# CITY OF ALBUQUERQUE

RE: **Lot 1 Block 5, S.A.D. 227**  
**Unser Cliffs Subdivision**  
**6524 Onyx Ct. NW**  
**Grading and Drainage Plan**  
**Engineers Stamp Date 10-24-18 (E10D053)**

LANG LOT 1 - GRADING & DRAINAGE PLAN

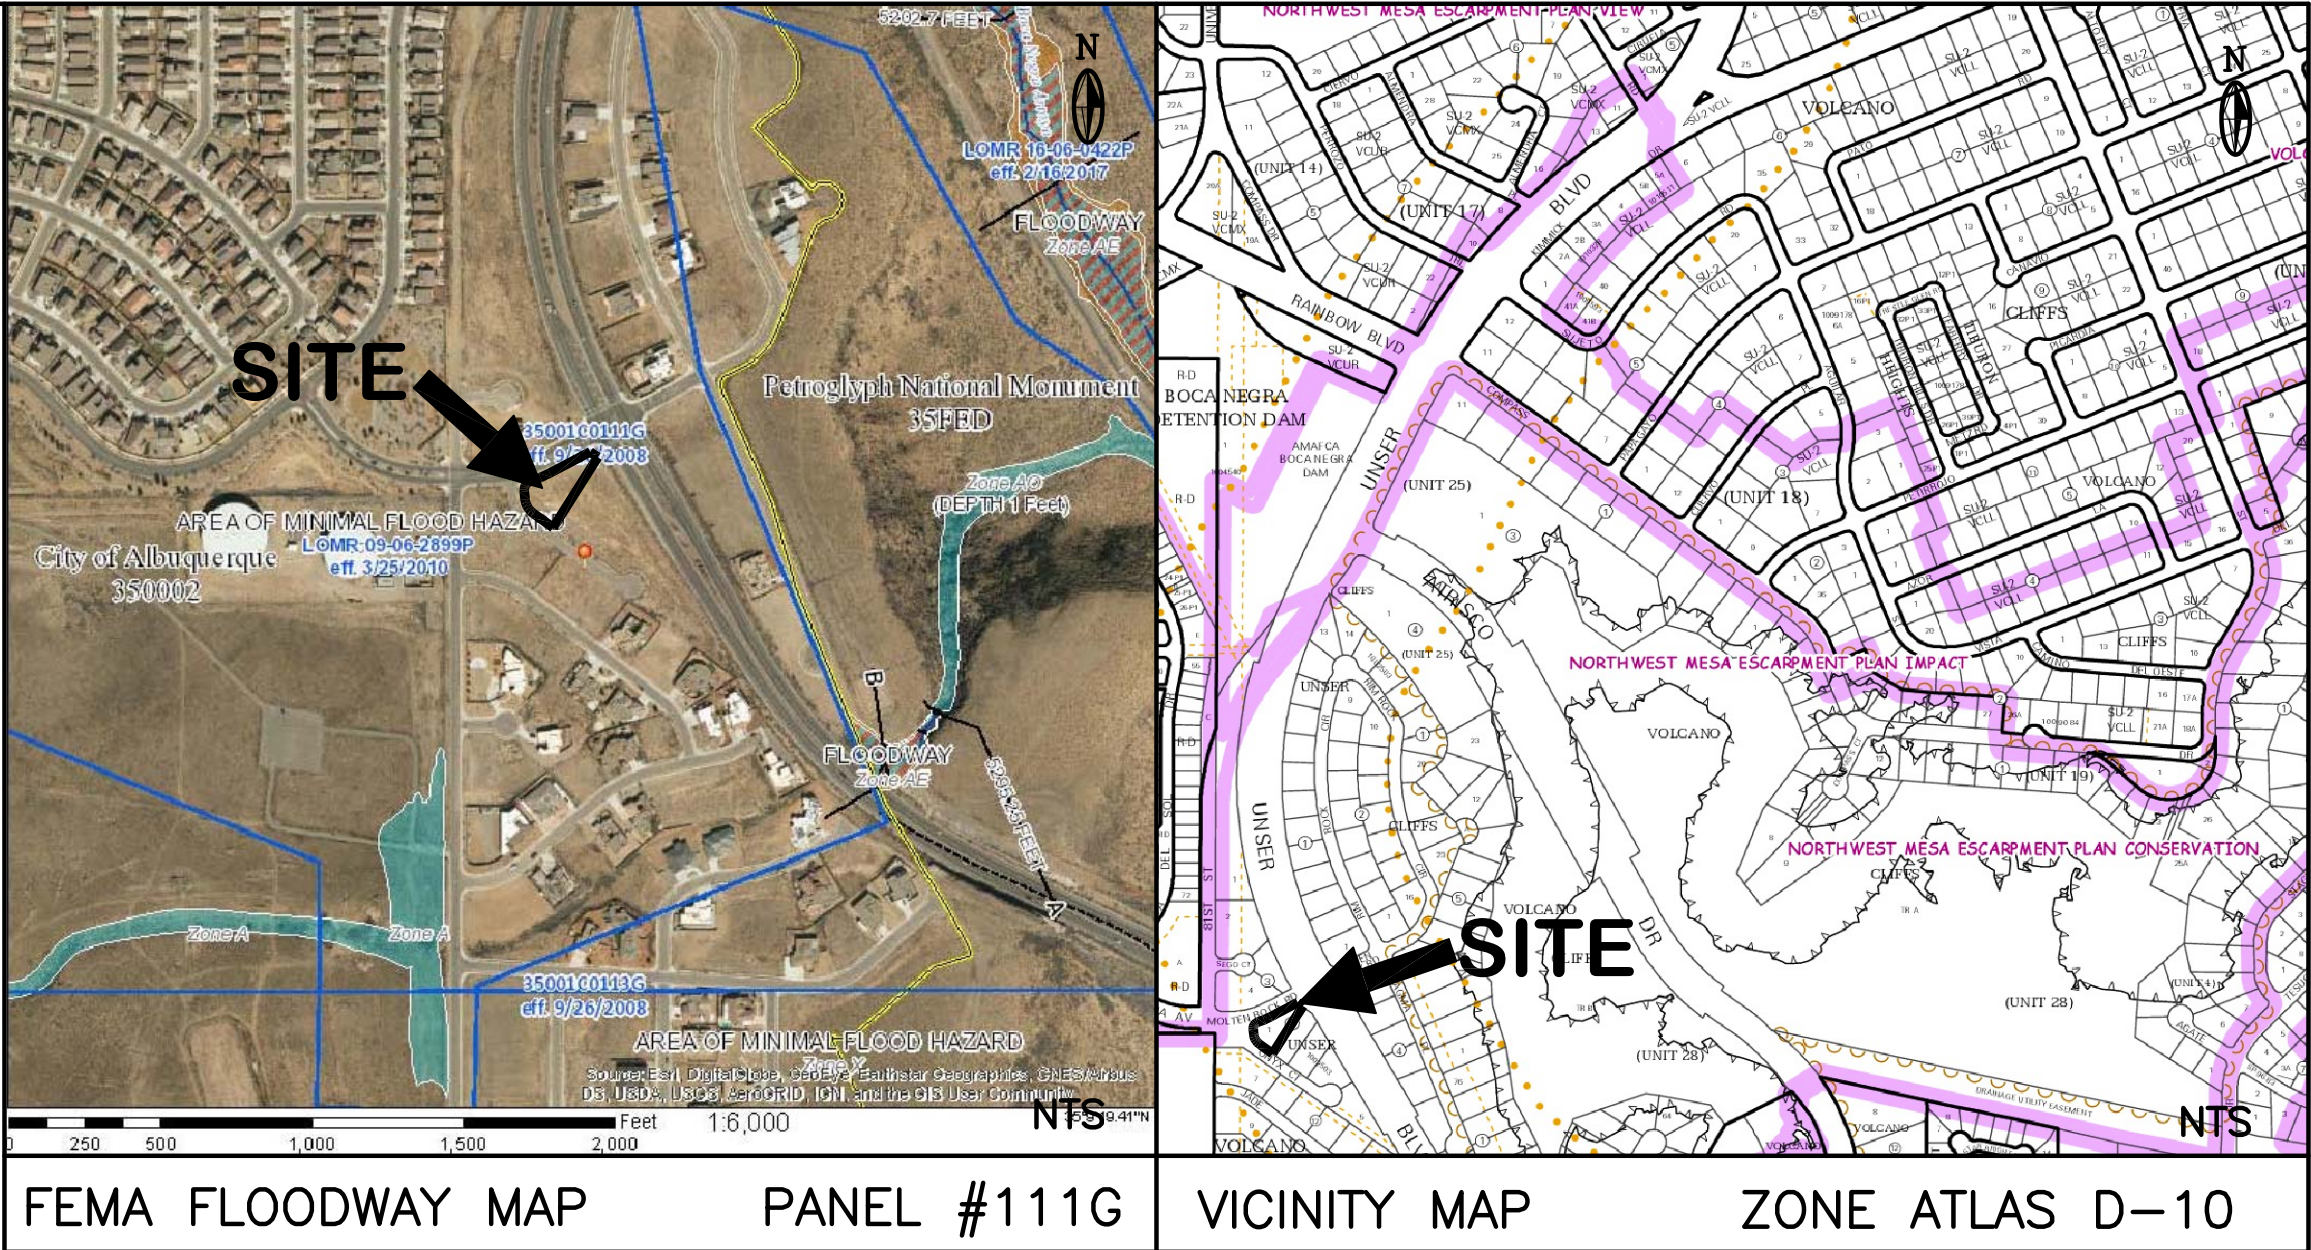
Based upon the information provided in your submittal received 10/23/18, this plan cannot be approved for Grading Permit until the following comments are addressed.

- Direct all flows to exit onto Onyx Ct. through a sediment capture pond.
- Cross lot drainage is not required; remove the turn blocks on the eastern garden wall.
- Remove the 7' PUE on the Molten Rock Rd. side.
